Determination 2017/040¹

Regarding the refusal to grant a building consent for proposed supermarket alterations at 347 Moorhouse Avenue, Sydenham, Christchurch

Figure 2: The layout of the building as proposed (not to scale)

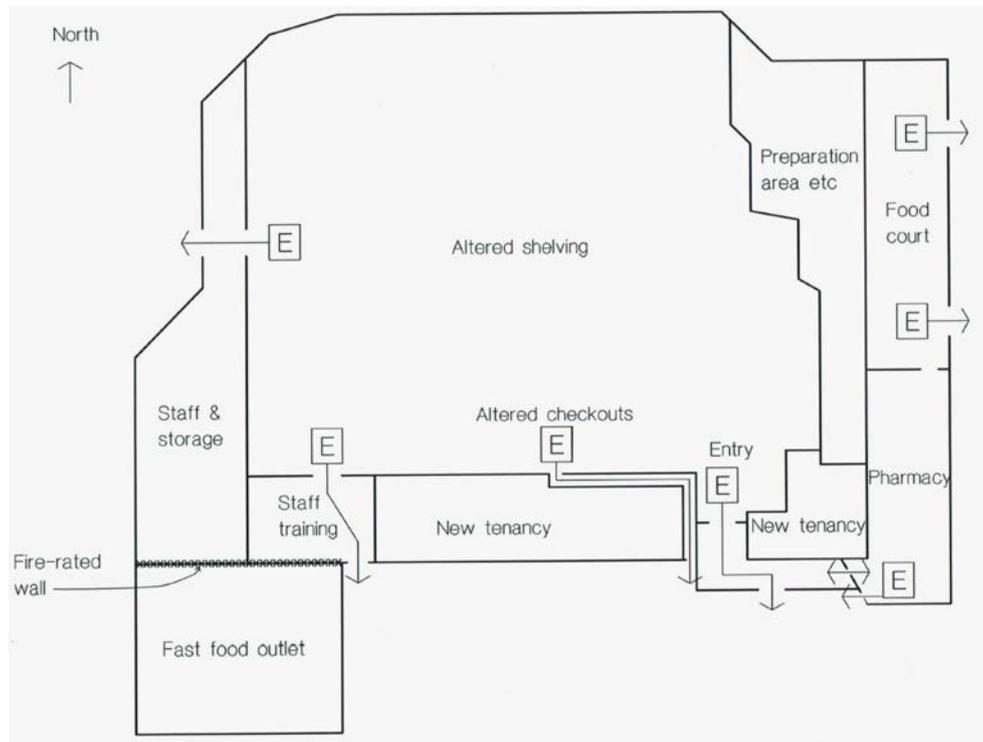
- confirm that design coordination had been carried out and an issue with security gates had been addressed to demonstrate that the assumptions of the means of escape assessment were valid – the expert noted that the security gates at the primary entrance appeared to have been removed from the revised architectural drawings.

- the fire design should be updated to include the adjacent tenancies, although the expert believed these could be assumed to be unoccupied spaces at this point and subject to C/VM2 design scenario CS¹⁷, which was satisfied by installing sprinklers
- the location of the building work should be clarified
- a mezzanine floor (indicated by stairs on the plans) should be included in the assessment and floor plans supplied for this.

- a design fire should be provided for the retail spaces created between the training room and the main entrance, as these were part of the building but not fire rated from the supermarket – the expert’s view was these could be assumed to be unoccupied spaces at this point and subject to C/VM2 design scenario CS, which was satisfied by installing sprinklers

- The Fire Service and the authority commented on some differences between details on the architect's report and in the fire design. The authority said it had identified specific issues that showed a lack of coordination, one of which was "sharks' teeth" that should not be located on escape routes and which had been noted in its RFI of 1 July 2016. However, the applicant said these had been removed; the architect confirmed these were not to be located on escape routes.
- The fire engineer said errors in the modelling outputs were printout errors only and that the peer reviewer had reviewed the correct modelling.
- The plans presented to the authority did not represent all exitways from the existing pharmacy next to the supermarket.

- 8.2.24 During the hearing it was mentioned that the plans presented to the authority did not represent all exitways from this pharmacy. However, this information was not available to the authority at the time it made its decision regarding building consent.

- 9.5 Regarding means of escape from the building, one approach could be to provide an exit pathway diagram that nominates designated exits and indicates populations assigned to those exits. This may indicate that by nominating the external doors from the pharmacy (which were not shown on the plans submitted for building consent) as a designated exit for means of escape, the impact of merging flows through the main foyer is minimised.
